Mid-Barataria Sediment Diversion (BA-153) Independent Technical Design Review

REVIEW OF 30% ENGINEERING DESIGN ALTERNATIVE REPORTS, PLANS AND SPECIFICATIONS

FINAL DRAFT REPORT

JANUARY 9, 2015

Figure 5-7. Rating curve for the Mississippi River near the proposed MBSD intake

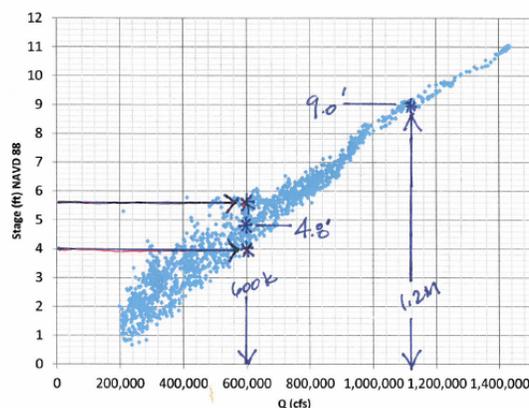
in the Mississippi River and a conservative tailwater condition of 6.0-ft to test the reliability of the structure in producing the design flow for the upper bounds of both the river and the receiving basin. Operational considerations were not taken into account. A 9.0-ft Mississippi River stage corresponds to an approximately 1.2M cfs flow. This assumes a condition where water may be piled up in the upper reaches of the basin for any of a number of reasons such as wind, tides and the outfall itself. Various geometries were reviewed and a structure configuration was developed to meet this flow in this most extreme condition. Under this condition the structure sized in the report can transport the water down the diversion channel and out into the basin with about a one foot head drop from the back of the gates to the outfall. This is a useful exercise, focusing on the upper bounds of the structure and flows. The above hydrograph of river stage demonstrates that the stage can fall between 4.0-ft at 600,000 cfs and 9.0-ft at 1.2M cfs. Nominal water levels in the basin run between 0.5-ft and 2.0-ft.
